DART AEROSPACE LTD		Work Order:	850980
Description: Crosstube High Fwd (205/212/412)		Part Number:	D212-664-101
Inspection Dwg: D212-664-141 Rev: C		Page 1 of 1

DESIGN PH	DRAWN BY PH	DART AEROSPACE LTD HAWKESBURY, ONTARIO, CANADA	
CHECKED QP	APPROVED PH	DRAWING NO. D212-664-141	REV. C SHEET 1 OF 3
DATE 07.03.08		TITLE XTUBE ASS'Y (205/212/412 HI FWD)	SCALE NTS
A	00.12.12	NEW ISSUE	
B	05.02.04	ADD HOLES FOR COMPATABILITY WITH BHT/AA SKIDTUBES	
C	07.03.08	REMOVE -851 ABRASION STRIP; ADD MAGNOBOND 6398, CUSHION, REVERSE CLAMPS

DRAWING NO. D212-664-141	TITLE CROSSTUBE	REV. C	DART AEROSPACE LTD ENGINEERING ORDER		D.E.O. NO. D212-664-141-C-1	SHEET NO. SHEET 1 OF 1	SCALE NTS
DRAWN <i>AD</i>	CHECKED <i>RS</i>	MFG. APPR. <i>EA</i>	APPROVED <i>AD</i>		DE APPR. <i>AD</i>		
DATE 09.05.01	DATE 09.06.15	DATE 09.06.15	DATE 09/06/16		DATE 09/06/16

FIGURE 1 - SUPPORT INSTALLATION

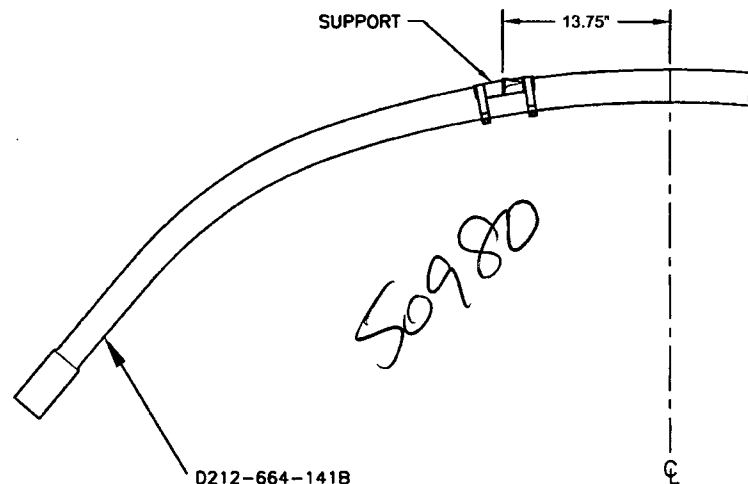
ADD THE FOLLOWING CROSSTUBE ASSEMBLY:

Part Number	Description
D212-664-141B	CROSSTUBE ASSEMBLY (214 HIGH FWD)

THE D212-664-141B CROSSTUBE HAS THE SAME PARTS LIST AS THE D212-664-141 CROSSTUBE. HOWEVER, INSTALL THE SUPPORTS AS SHOWN IN FIGURE 1 OF THIS ENGINEERING ORDER. THE NEW KIT IS OTHERWISE ASSEMBLED PER THE D212-664-141 CROSSTUBE.
